MARINE MAMMAL COMMISSION

23 August 2018

The Marine Mammal Commission (the Commission), in consultation with its Committee of Scientific Advisors on Marine Mammals, has reviewed the application submitted by Port of Kalama (POK) seeking authorization under section 101(a)(5)(D) of the Marine Mammal Protection Act (the MMPA) to take small numbers of marine mammals by harassment. The taking would be incidental to construction of the Kalama Manufacturing and Marine Export Facility on the Columbia River in Washington. The Commission also has reviewed the National Marine Fisheries Service's (NMFS) 14 August 2018 notice (83 Fed. Reg. 40257)¹ announcing receipt of the application and proposing to issue the authorization, subject to certain conditions.

POK plans to construct a new marine terminal for loading methanol on the Columbia River. Operators would install up to 320 24-in concrete piles using an impact hammer and 16 12- or 18-in steel piles using both a vibratory and an impact hammer. They also would install and remove temporary steel piles using a vibratory hammer throughout the project. POK expects activities to take 153 days, weather permitting. It would limit pile-driving and -r

Figure 1. Predicted low frequency (one-third octave centered at 100 Hz) average annual noise levels at 30 m depth, summing contributions from a variety of human activities (http://cetsound.noaa.gov/sound_data).

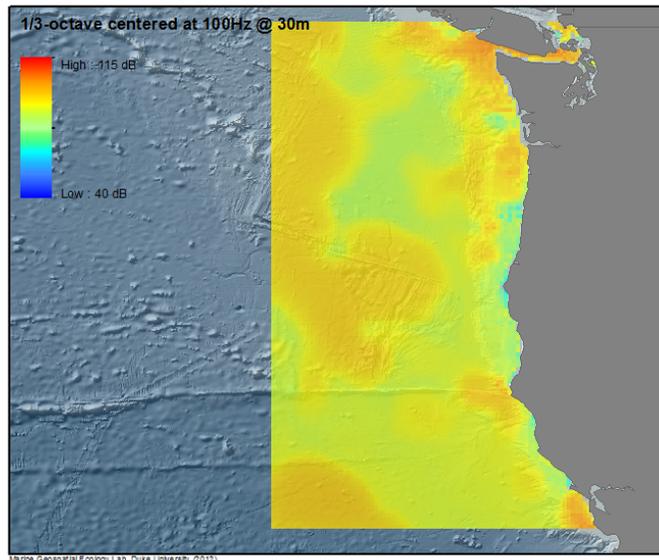
NOAA’s SoundMap and CetMap mapping tools show that human-caused cumulative and ambient ocean noise pollution has increased ambient sound levels to over 100 decibels (dB) in waters off the coast of Oregon and Washington (see figure 1, below).³⁵ The growth of commercial ship noise could increase this by up to a factor of 1.9 by 2030.³⁶ Continued growth in the number of ships (container ships, oil tankers, and bulk carriers), quantity of goods carried, and the distances traveled feed into the dramatic increase in the predicted ocean noise level.³⁷
